# **RECOMMENDATION MEETING**

Thursday, June 20th, 2019 6:30pm

2 **HYBRID** EDG 3032048

# 2305 S. PLUM ST **APODMENTS**

# MASSING 1 Response to Guidance

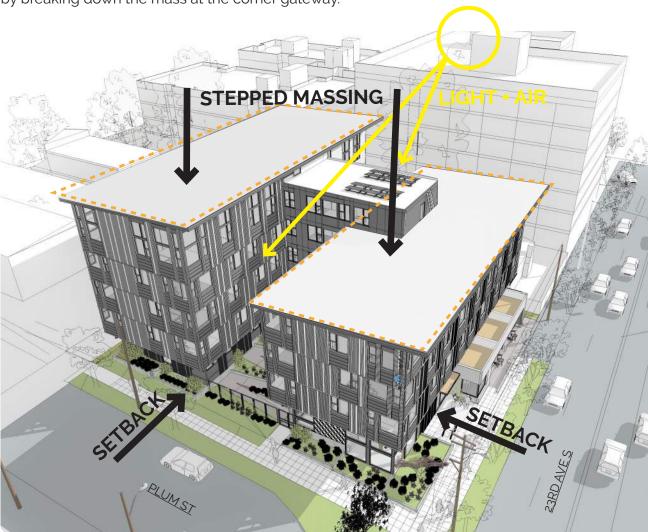
The Board agreed the revised massing, 'Corner Court', was responsive to the provided 1st EDG guidance. The 'H' shaped massing successfully engages the gateway corner, maximizes light and air to the units, and maintains south facing courtyard toward the neighboring site. The Board expressed support for the bridge, which contains north facing residential units and south facing common space. The Board noted the ground level setback at the corner and central courtyard, with upper building cantilever, as successful. (CS1-B1, CS1-1a, CS3-A2, DC3-A. DC3-1)

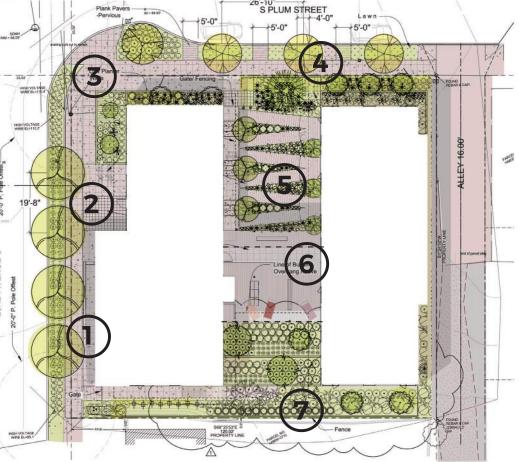
a. Develop the ADA path to meander, maximize landscaping, and utilize planting materials that will thrive in the north facing condition, (PL1-2)

The open space and landscape concept has been developed to thrive in the north-facing condition through collaboration with the landscape architect. The ADA path continues to meander through the central courtyard, along planter beds and trees. Durable materials including concrete retaining walls have been incorporated along the planting edges to define the path. The landscaped planters will provide a rich and vibrant color that can spill into other parts of the building and unify the development's identity.

The concrete planters will also be incorporated at Plum Street and along the 23rd Ave S to buffer the street edge and provide additional textural richness at the pedestrian experience.

PLAN THROUGH COURTYARD / LOBBY / BUILDING ENTRY

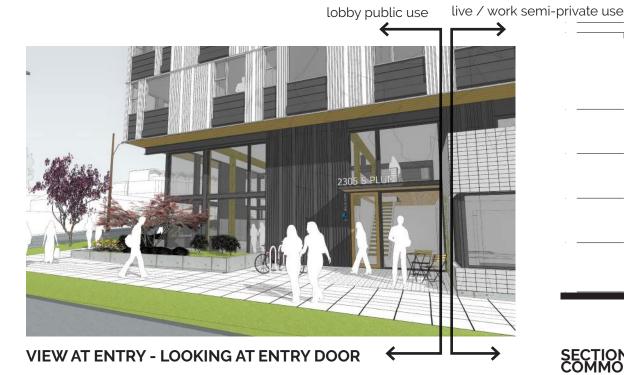
e Develop the common space to directly engage the central courtyard. Investigate a stair design that facilitates movement between the between courtyard and the street, and (PL1-1, PL3-A, DC3)

f. Program the corner common space to accommodate spaces that are visible from the street and others that are private. (PL1-1, DC1-A)

Glazing was extended lower to provide a more clear connection towards the central courtyard and the stairs has been re-oriented to draw residents and guests up and through the building in a more direct fashion, with the stair landings aligning with the transparency of the common space.

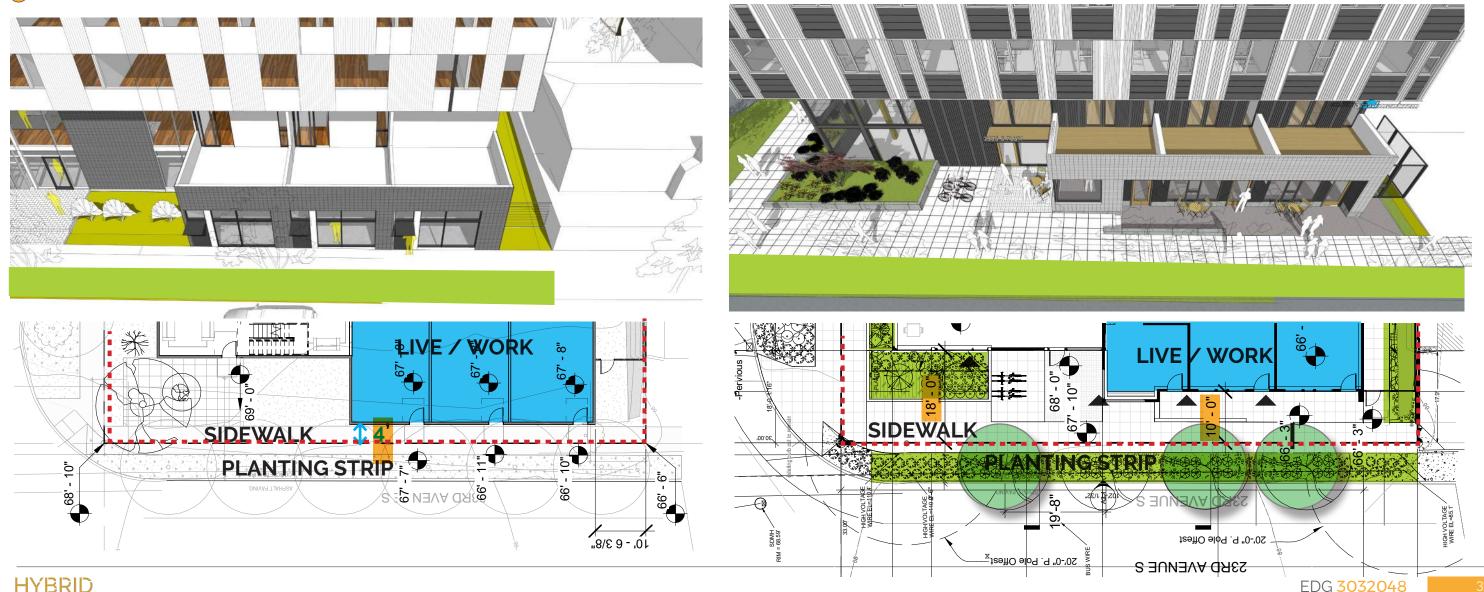
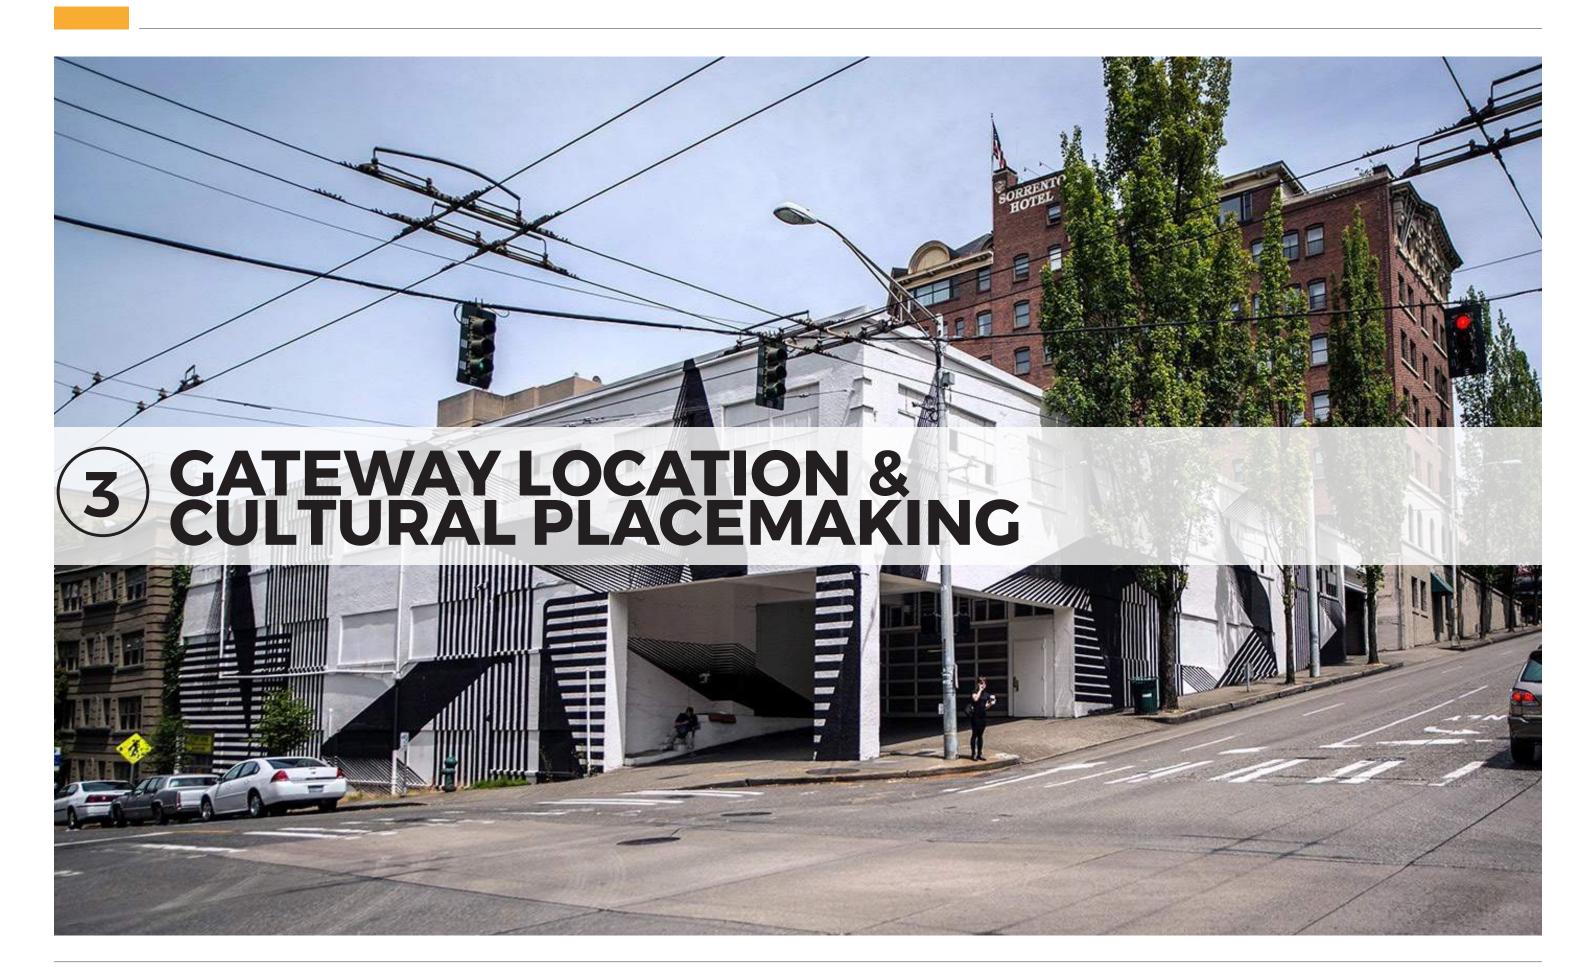
C Develop the setback space directly south of the 23rd Avenue S entry to include passive landscaping, address resident privacy, and provide a big gesture to the pedestrian experience, (PL-A, PL1-2, DC3-A)

d.) Wrap live work fenestration onto the north wall, (PL3-1, DC1-A)

The sidewalk has been extended to allow additional buffer / active space between the live / work units and the sidewalk off of 23rd Ave S. The additional hardscape area will allow for planters, seating and additional amenities as to encourage local community organizations or small business to lease the space. The original massing of the live/work units were 4'-0" from the property line and proposed to utilize a planting strip in the SDOT right of way. The developed design pushes the mass in even more allowing 10'-0" from the property line. Taking cues from SDOT 23rd Avenue Street improvements, the sidewalk is proposed to be widened as a big gesture towards the pedestrian experience. A planting strip and planting buffer have also been incorporated. The brick cladding/ fenestration is wrapping all sides of the live/work mass.

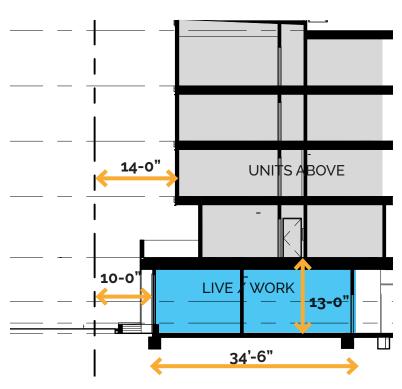
a. The Board encouraged a small planting buffer between the sidewalk and live work spaces to provide a small buffer and sense of privacy. (CS2-B2, PL3-1, DC1-A)

b The Board requested the applicant explore increasing the height of the live work space to accommodate a small sleeping loft. (CS2-B2, PL3-1, DC1-A)

c. The Board noted the design and occupancy of the small commercial spaces provide an opportunity to work with the local community organizations including the Central Area Collaborative and Africatown. (A1.1)

The live / work units have been developed to further increase the usability, livability and design of the residents, community businesses and guests. The design team studied precedent of successful live/work spaces (next page) in order to more fully understand how to create more commercially minded spaces. The study informed the elimination of the planting buffer in favor of expanded sidewalk space for possible outdoor seating, allowing visitors to more easily access the storefronts without barrier.

After feedback from the neighboring community and precedent study, the planting strip between the live / work units and the sidewalk has been removed as a way to remove barriers from visitors and guests entering the more commercial centered space - design encourages outdoor seating and planters.

Laser Cut Metal Signage

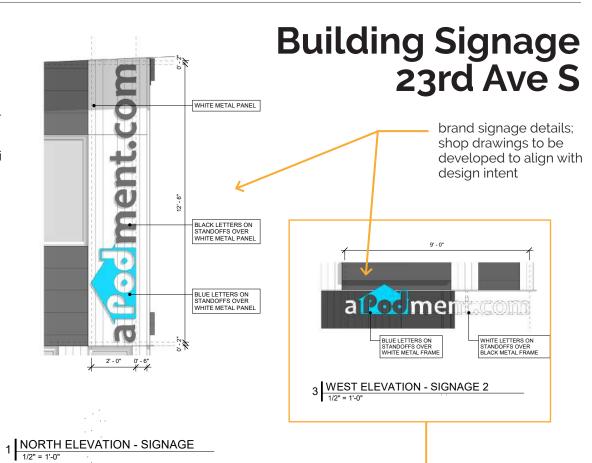
The Board provided guidance that all branding signage should include materiality and dimension consistent with the precedent images. At the Recommendation Meeting the Board requested a signage plan that is unique to this building. (CS3-B1, B2, PL1-2c, DC4-B1 and 2, A.1-1a through f, A.2-1a)

The signage design has been developed to promote wayfinding and building identity by the use of well-placed, composed laser cut metal signage. The design is materially and dimensionally consistent with the precedent images presented during EDG2 and a signage plan has been provided that further indicates the signage location on the building.
